ARACO CONCRETE

SITE DEVELOPMENT PLAN EL PASO COUNTY, COLORADO

PCD FILE NO. PPR1950

ARACO CONCRETE
SITE DEVELOPMENT PLAN
A PORTION OF THE SOUTHEAST QUARTER OF SECTION 24,
TOWNSHIP 15 SOUTH, RANGE 66 WEST OF THE 6TH P.M.,
EL PASO COUNTY, COLORADO

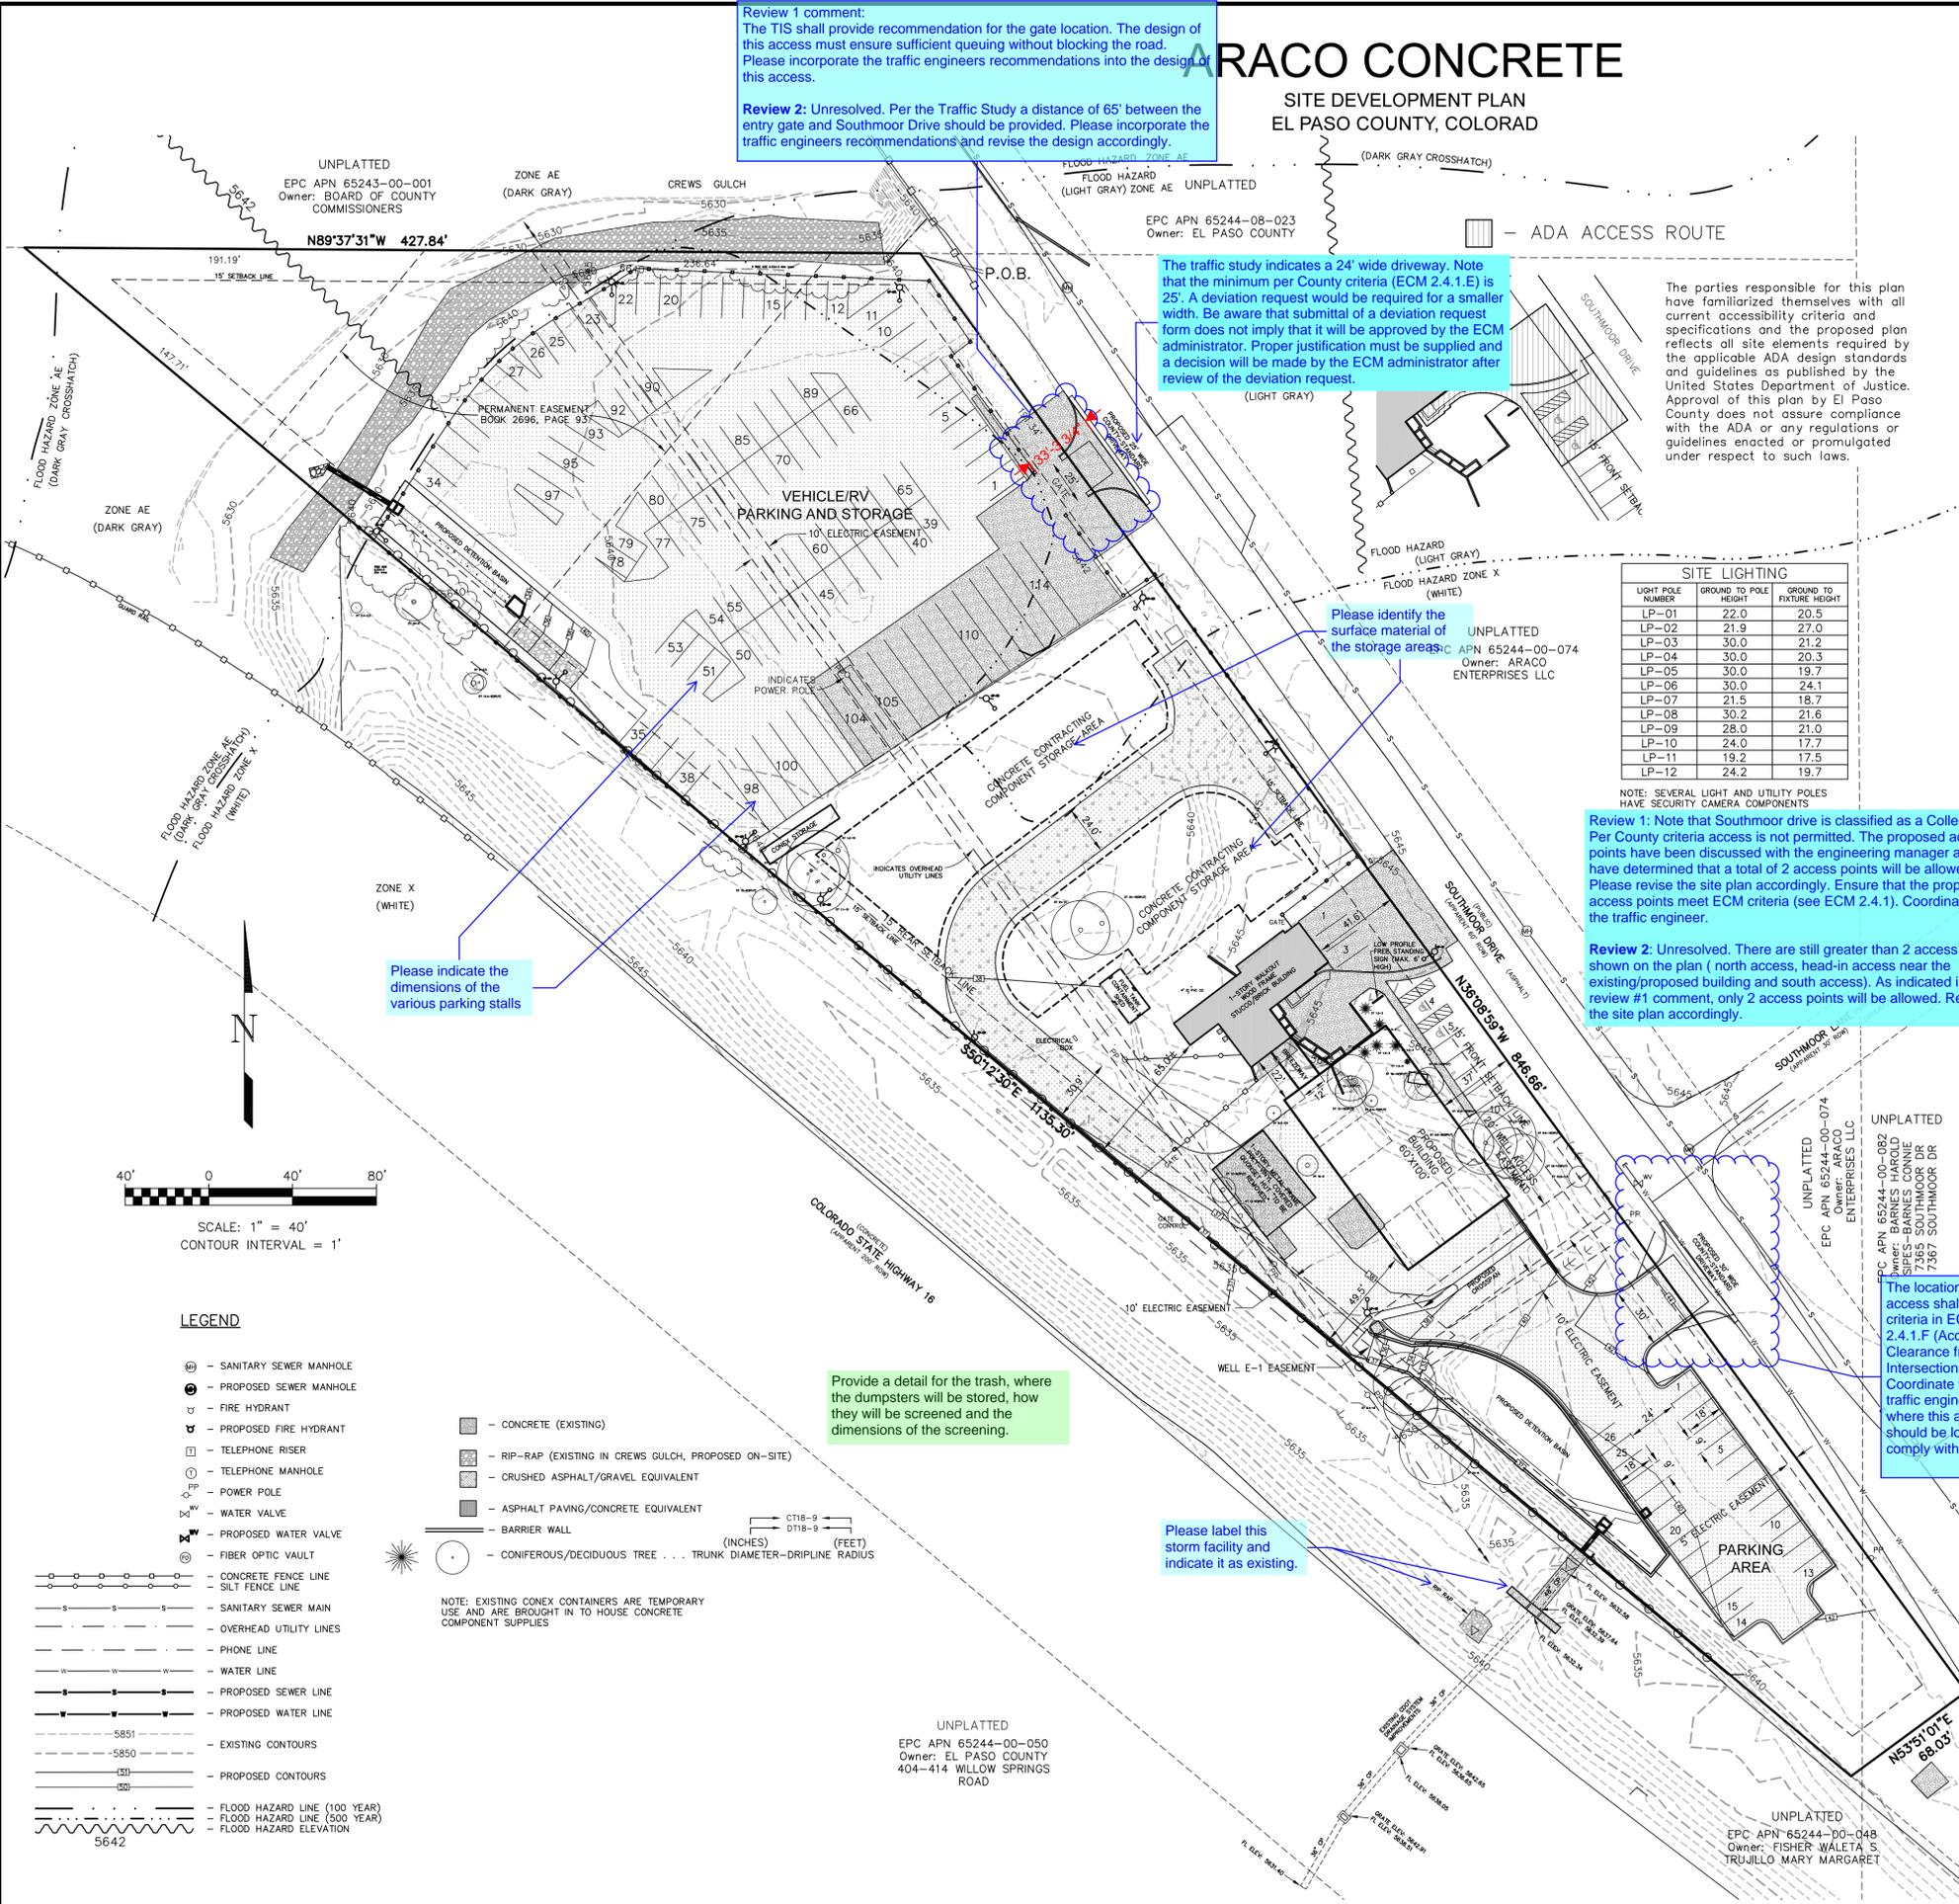
Review 1 comment:
The TIS shall provide recommendation for the gate location. The design of this access must ensure sufficient queuing without blocking the road.
Please incorporate the traffic engineers recommendations into the design of this access.

Review 2: Unresolved. Per the Traffic Study a distance of 65' between the entry gate and Southmoor Drive should be provided. Please incorporate the traffic engineers recommendations and revise the design accordingly.

The traffic study indicates a 24' wide driveway. Note that the minimum per County criteria (ECM 2.4.1.E) is 25'. A deviation request would be required for a smaller width. Be aware that submittal of a deviation request form does not imply that it will be approved by the ECM administrator. Proper justification must be supplied and a decision will be made by the ECM administrator after review of the deviation request.

Please identify the surface material of the storage areas.

Review 1: Note that Southmoor drive is classified as a Collector. Per County criteria access is not permitted. The proposed access points have been discussed with the engineering manager and we have determined that a total of 2 access points will be allowed. Please revise the site plan accordingly. Ensure that the proposed access points meet ECM criteria (see ECM 2.4.1). Coordinate with the traffic engineer.

Review 2: Unresolved. There are still greater than 2 access points shown on the plan (north access, head-in access near the existing/proposed building and south access). As indicated in the review #1 comment, only 2 access points will be allowed. Revise the site plan accordingly.

The location of this access shall meet the criteria in ECM Section 2.4.1.F (Access Clearance from Intersections). Coordinate with your traffic engineer as to where this access should be located to comply with the criteria.

Provide a detail for the trash, where the dumpsters will be stored, how they will be screened and the dimensions of the screening.

Please label this storm facility and indicate it as existing.
